<b>Project</b>	<b>IEEE 802.16 Broadband Wireless Access Working Group</b> < <a href="http://ieee802.org/16">http://ieee802.org/16</a> >	
<b>Title</b>	<b>Procedures for spectrum sharing with specific spectrum users</b>	
<b>Date Submitted</b>	<b>16 Sept 2006</b>	
<b>Source(s)</b>	Mariana Goldhamer Alvarion Tel Aviv, 21 HaBarzel Street Israel	Voice: +972 544 22 55 48 mailto:mariana.goldhamer@alvarion.com
<b>Re:</b>	IEEE 802.16h-06/015r1 – Working Group Review	
<b>Abstract</b>		
<b>Purpose</b>	Provide content for the 802.16h Working Document	
<b>Notice</b>	This document has been prepared to assist IEEE 802.16. It is offered as a basis for discussion and is not binding on the contributing individual(s) or organization(s). The material in this document is subject to change in form and content after further study. The contributor(s) reserve(s) the right to add, amend or withdraw material contained herein.

# Procedures for spectrum sharing with specific spectrum users

Fig. xx: Architecture for coexistence of BWA and preferred radio applications

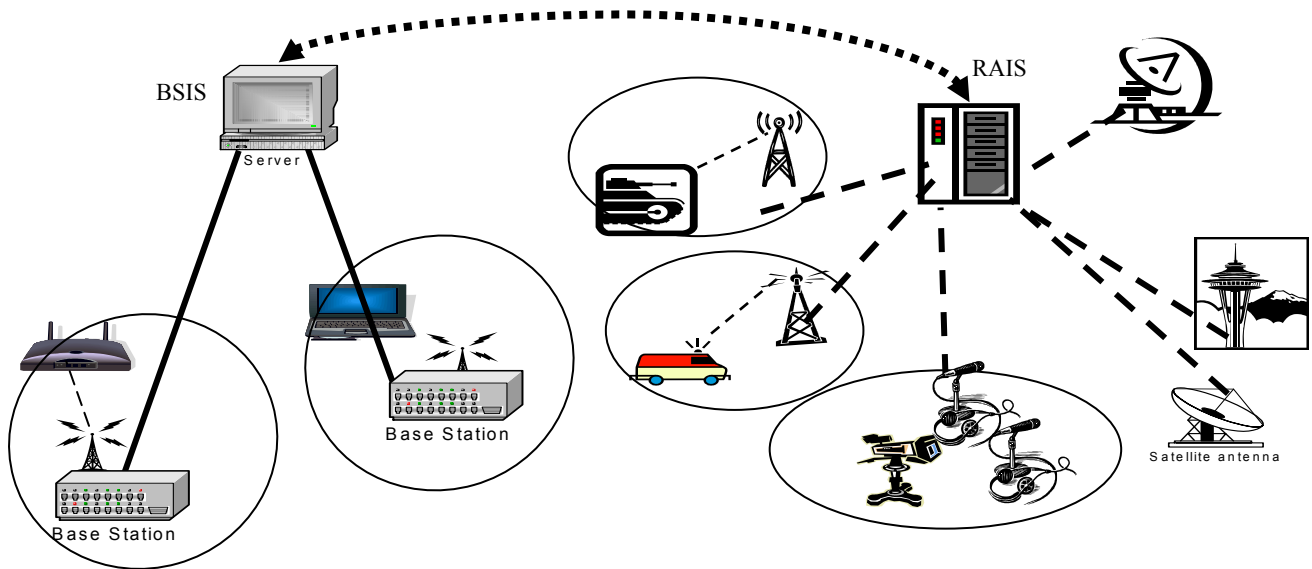
The fig. xx give an example of the proposed architecture. To the BSIS are connected the Base Stations providing BWA services. The RAIS has connections with the Base Stations providing TV applications, Satellite applications, Military applications, Health applications, Security applications, etc. In all these cases secure communication shall be established between the RAIS and the Base Stations or the Service Providers providing these services.

A special class are the Ad-Hoc protected applications, as wireless microphones or TV car transmissions, which are mobile ad-hoc protected applications. In this situation will be established a secure communication between a Laptop with cellular interface or a hand-held device and the RAIS.
